UNITED STATES PATENT AND TRADEMARK OFFICE

APPLICATION NO.	FILING DATE	FIRST NAMED INVENTOR	ATTORNEY DOCKET NO.	CONFIRMATION NO.
10/689,813	10/20/2003	Richard Cooper	3060-3	4362

Office Action Summary

DETAILED ACTION

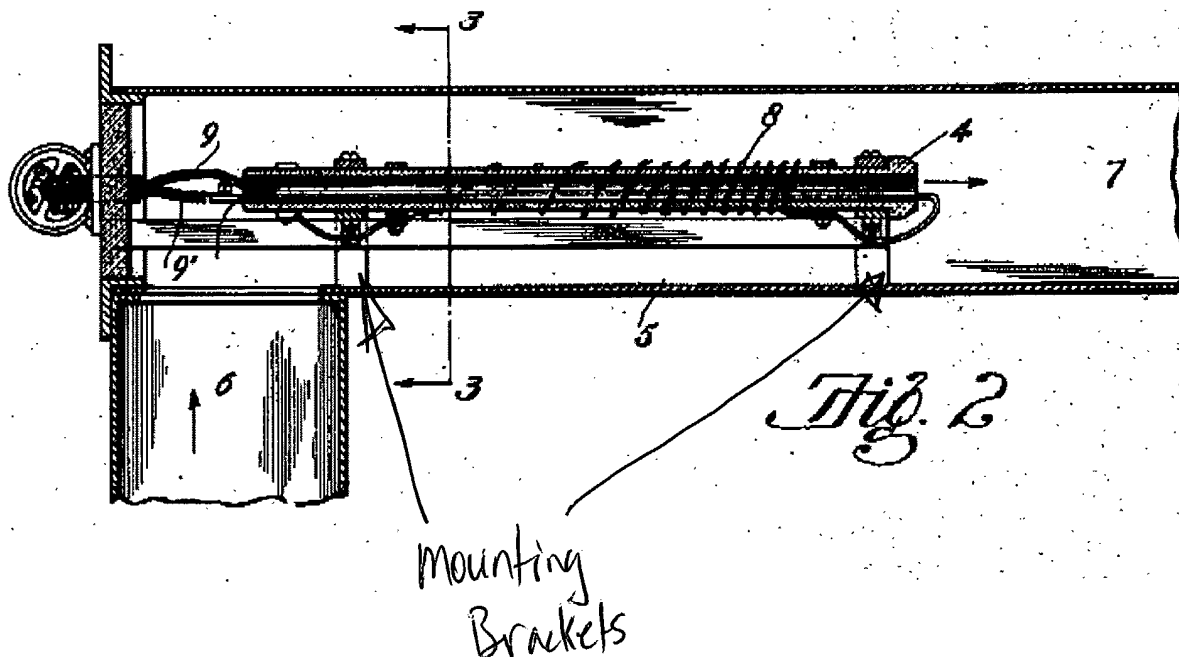
Claims 1, 3, 13, 15, 17, 23, 25, 16, 18, 24, and 27 are rejected under 35 USC 102(e) as being anticipated by Park (US 2003/0116559). Park (US 2003/0116559) discloses a heater comprising insulative substrates in the form of tubes 24 in Figs. 3

and 4 and thin film electric heater coatings 26 deposited on the tubes. Fan 35 moves air thereacross. See Paras. 0032-0033.

In another embodiment, the insulative substrate comprises plates 12 each coated with thin film electric heaters 14. See Figs. 1 and 2. Air is moved thereacross by fan 18. See Para. 0031.

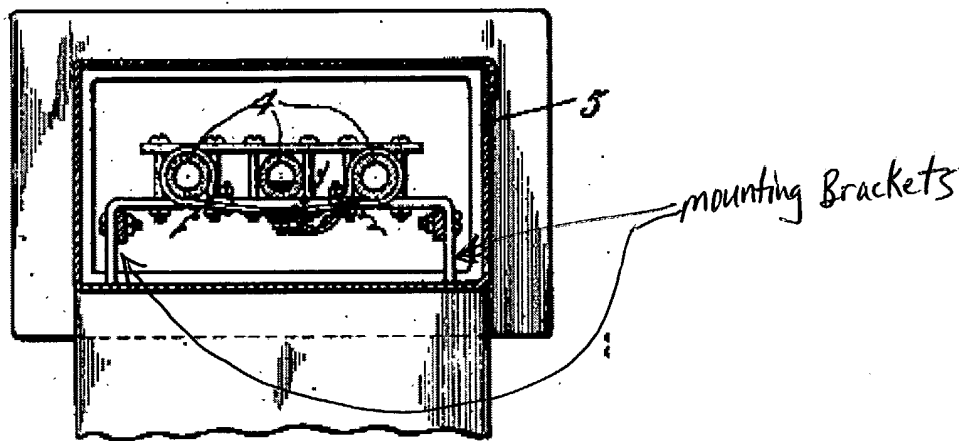
Claims 4-8, 11, 12, 19, and 20 are rejected under 35 U.S.C. 103(a) as being unpatentable over Park (US 2003/0116559) in view of Burger (US 1,491,194). The claims differ from the previously cited prior art in calling for the housing to have one mounting bracket protruding from an inner surface of the housing and the tubes to be mounted in the mounting bracket. Providing a surrounding housing for a tubular heating element and providing a protruding mounting bracket from the inner housing surface is conventional and well known in the art as evidenced by Burger (US 1,491,194) noting surrounding housing 5 and unlabelled mounting brackets that protrude from the housing's inner surface. Figs. 2 and 3 of Burger (US 1,491,194) are reproduced below to clearly show the mounting brackets.

As shown in Burger (US 1,491,194), such an arrangement confines airflow to a defined volume dictated by the housing and centralizes the heater tubes within the housing. In view of Burger (US 1,491,194), it would have been obvious to one of ordinary skill in the art to provide a surrounding housing and mount the heater tubes in brackets protruding from the housing so that air to be heated is confined to a defined volume dictated by the housing and the heater is centralized within the airflow thus more uniformly heating the air.
